VOX R&D UK

MODEL	AC15	TITLE	AC15 TYPE1 SCHEMATIC
ISSUE	ISS3c		
DRAWN	DC 08/11/05	DWG.No	AC15 NEWTYPE 3 ISS3d.DGM
CHECKED			
APPROVED

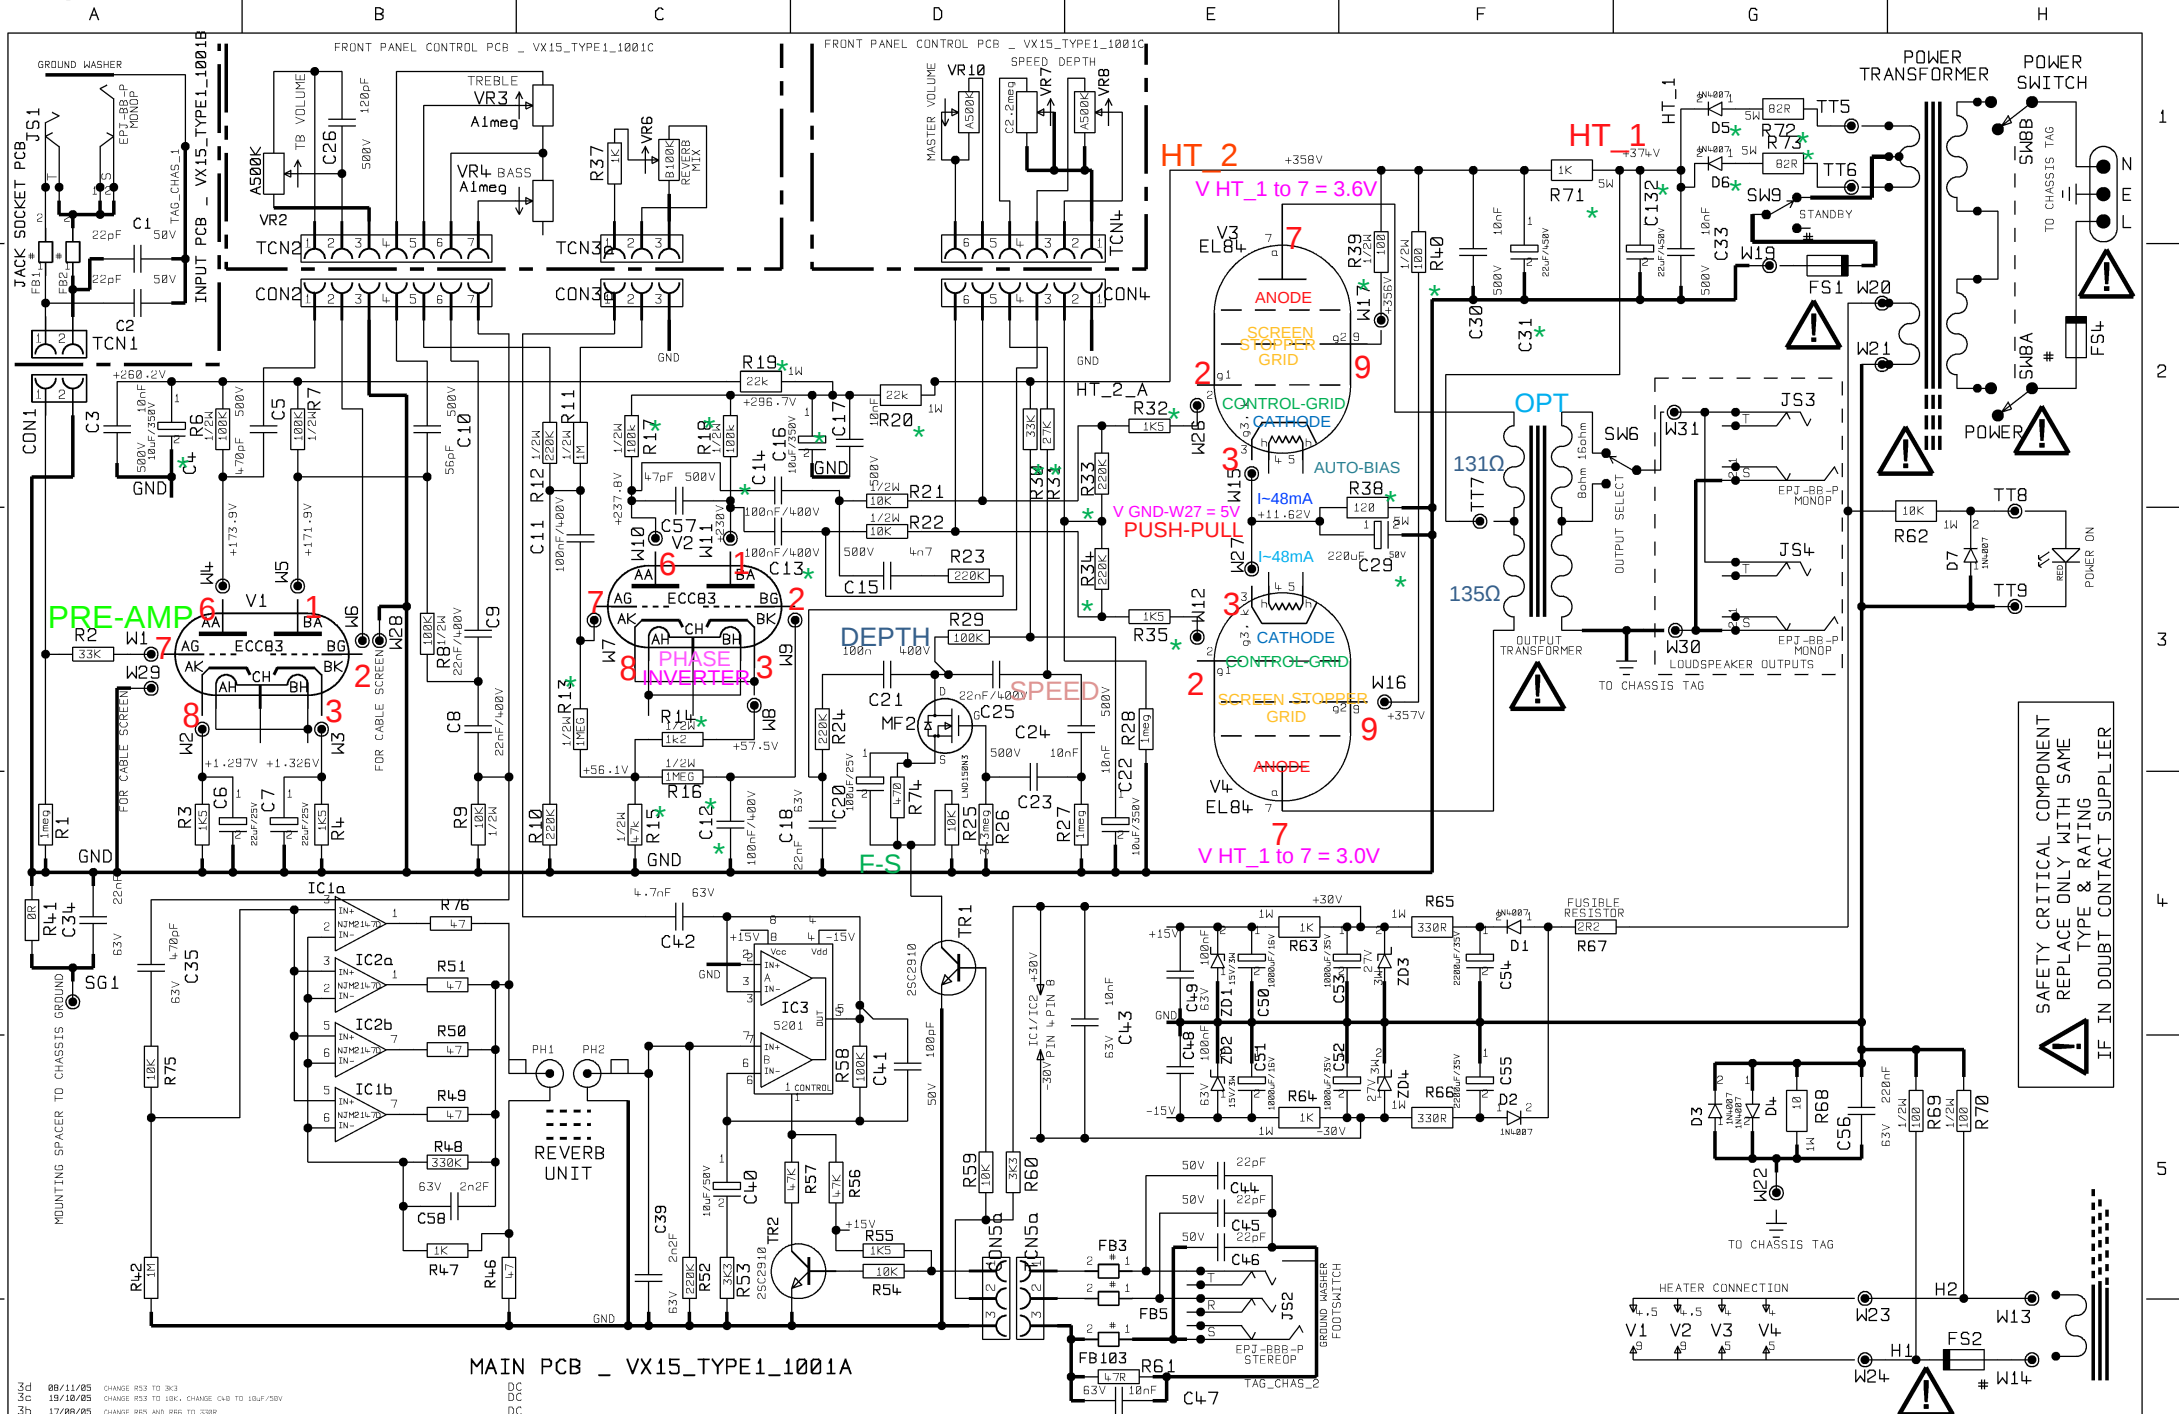
3d	08/11/05	CHANGE R53 TO 3K3	DC
3b	15/10/05	CHANGE R53 TO 10K, CHANGE C40 TO 100P/50V	DC
3a	17/08/05	CHANGE RES AND RES TO 330K	DC
3a	09/08/05	ADD C38 AND CHANGE R18, R20 TO 1 WATT RATING, CHANGE RES AND RES TO 220R AND OTHER CHANGES	DC
3	25/07/05	ADD JACKS FOR OUTPUT SHAP OFF BOARD	DC
2d	07/07/05	CHANGE R71, R72, R73, R74, R75, R76, R77, R78, R79, R80, R81, R82, R83, R84, R85, R86, R87, R88, R89, R90, R91, R92, R93, R94, R95, R96, R97, R98, R99, R100, C57 VALUES AND AMP VOLTAGES	DC
2c	30/06/05	CHANGE R41 & R10 VALUES AND ADD VOLTAGES	DC
ISS	DATE	CHANGE	SIGNED
